July 17, 2018

Product Improvement Notice - Solera® Slide Topper Shield improvement

Fig.1

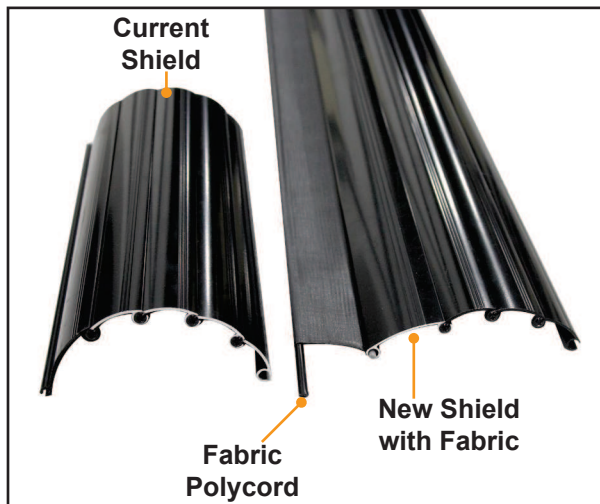
A fabric piece with a polycord is being added to the slide topper shield (Fig. 1) that will increase flexibility and improve functionality of the slide topper as it is retracted.

Previously, the shield was comprised of all metal links. The new design removes one link and adds the fabric piece, which makes the shield more flexible and helps to protect the unit wall. The new design is also less curved when extended, which allows the awning to open flatter and improve water run off management.

Fig.2

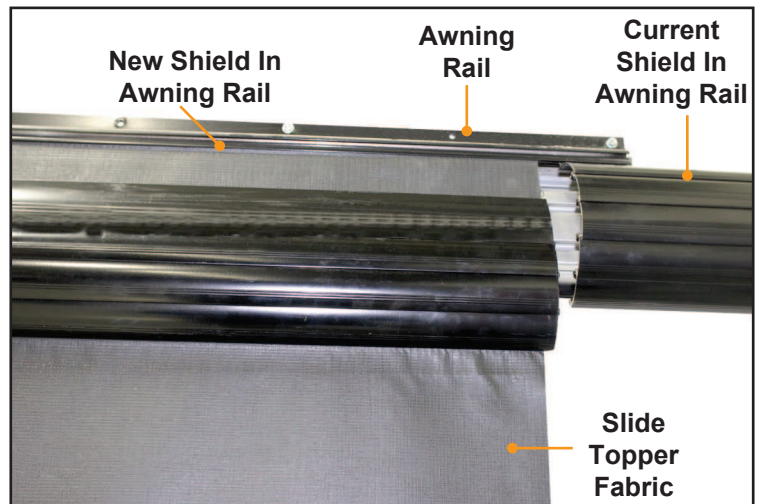
The new design installs similarly to the previous design. Previously, one link in the shield slid into the awning rail and the awning polycord slid into the shield. With the new design, the polycord in the fabric piece will slide into the awning rail, with the awning polycord sliding into the opposite end of the fabric shield (Fig. 2).
